REVISED RESPONSE TO REQUEST FOR ADDITIONAL INFORMATION

APR1400 Design Certification

Docket No. 52-046

RAI No.: 199-8223
SRP Section: 03.08.01 – Concrete Containmentment
Application Section: 03.08.01
Date of RAI Issue: 09/08/2015

E6-43 Post-tensioning System

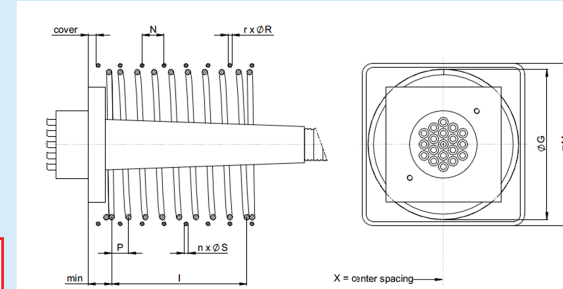
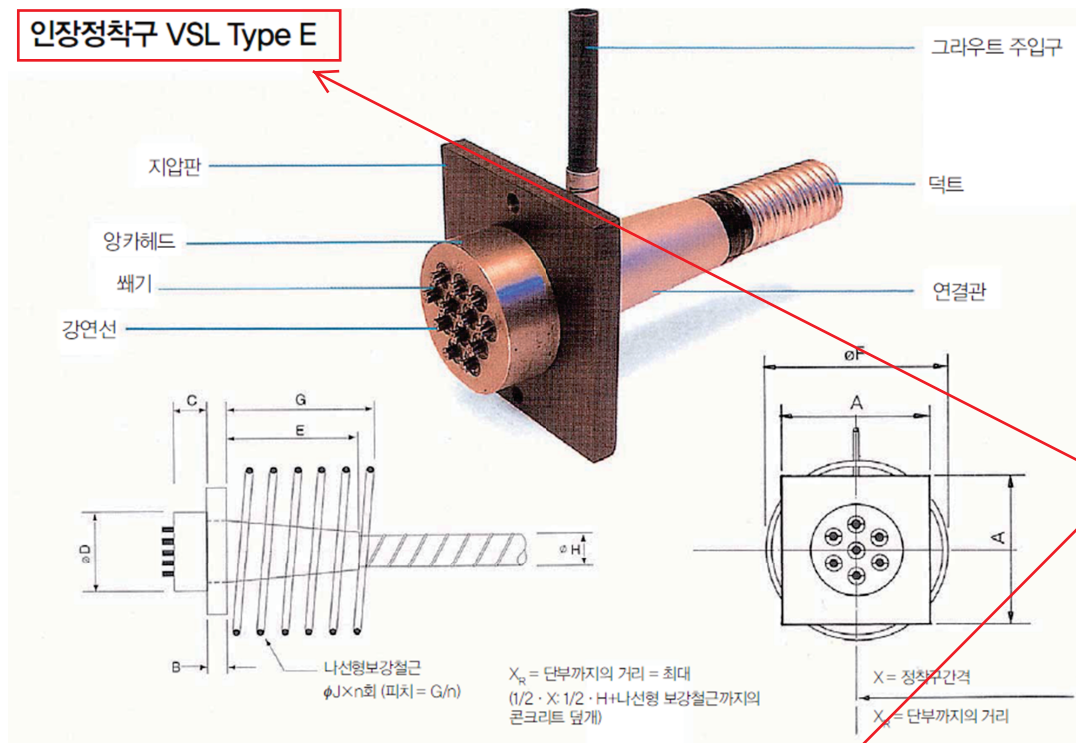
DCD Section 3.8.1.5.1.2, "Prestressing System," identifies the material for the prestressing elements and in the case of the anchorage components, refers to the tendon manufacturer's respective material specifications. However, the staff was unable to find the manufacture's specifications for the bearing plates, anchor head assemblies, and the wedges which are part of the anchorage system Per Appendix A to 10 CFR Part 50, GDC 1, 2, 4, 16 and 50; and SRP 3.8.1, the applicant is requested to identify what manufacture tendon system is used for the design of APR1400, and if the information is not publicly available, provide the manufacturer's technical literature on this type of tendon system, including their anchorage system.

The post-tensioning system of the containment is VSL E6-42 multi-strand system using a wedge block with wedge type anchors. VSL E6-42 multi-strand system uses the same anchorage system as VSL E6-43 which is identified in the VSL [International Brochure \(Attachment 1\)](#) available to the public. Although the VSL E6-42 system is not listed in the VSL International Brochure, it is introduced in the VSL Korea Brochure (Attachment 2). A translation of the VSL Korea Brochure is provided in Attachment 2 as well.

The VSL International Brochure is summarized in the VSL Korea Brochure which provides only one option of material properties without any other options. In this process, different material properties were used to consider the local conditions. The dimensions in certain anchorage types indicated in the brochures may vary with material properties, including concrete

compressive strength, yield strength of reinforcing steel and tendon stressing force. The dimensions which do not match between the VSL International and Korea brochures come from the difference of material properties applied in both brochures.
